Service Bulletin

Bulletin No.: 21-NA-017

Subject: Rattle or Creak Noise Heard Coming From Driver Left Rear Quarter Panel Area When Driving Over Bumps

5721198

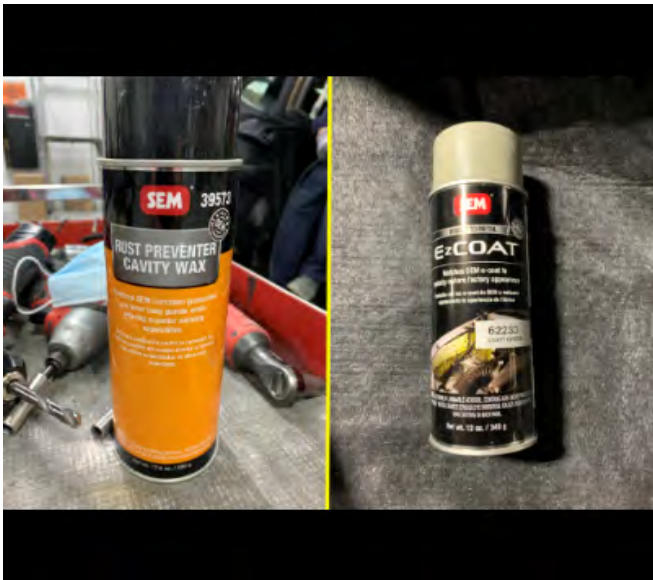
5. De-burr and prep the inner panel for Mig welding.

6. Mig weld the drilled hole areas.

5241734

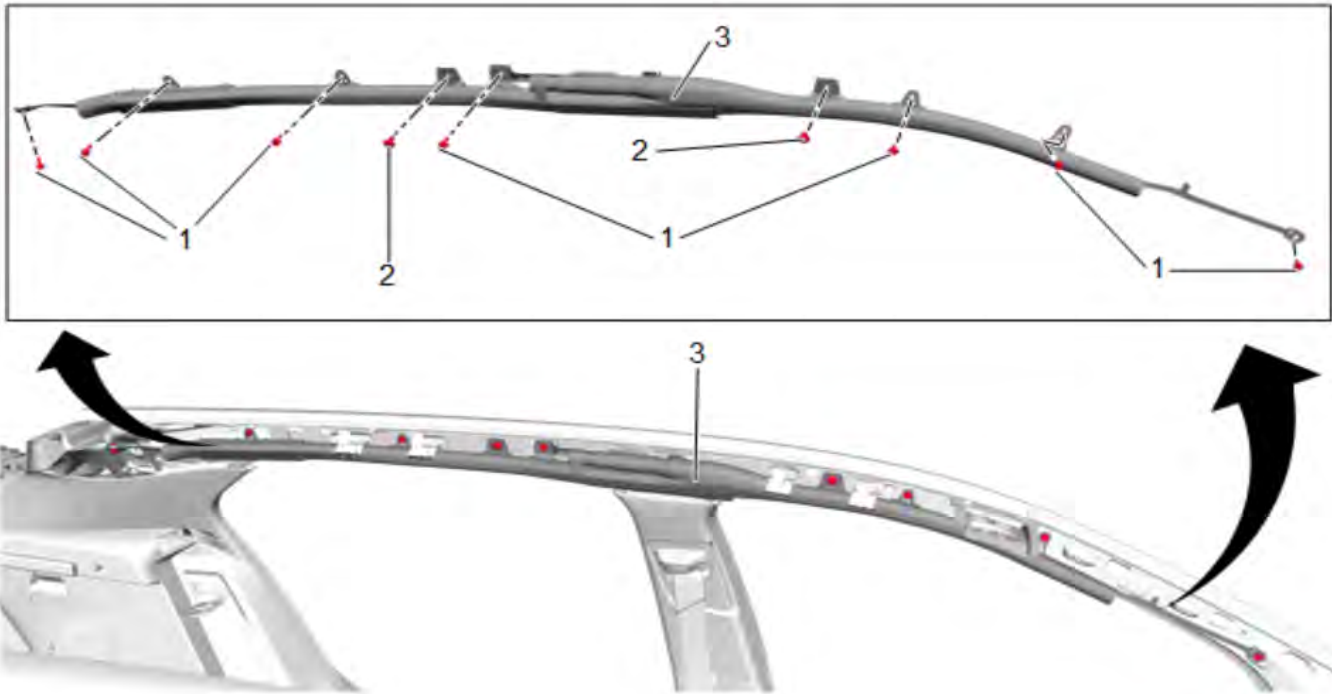
8. Reinstall the left rear row seat roof rail airbag (3) and the headliner. Refer to *Front and Rear Row Seat Roof Rail Airbag Replacement*, in SI.
9. Enable the SIR system. Refer to *SIR Disabling and Enabling*, in SI.
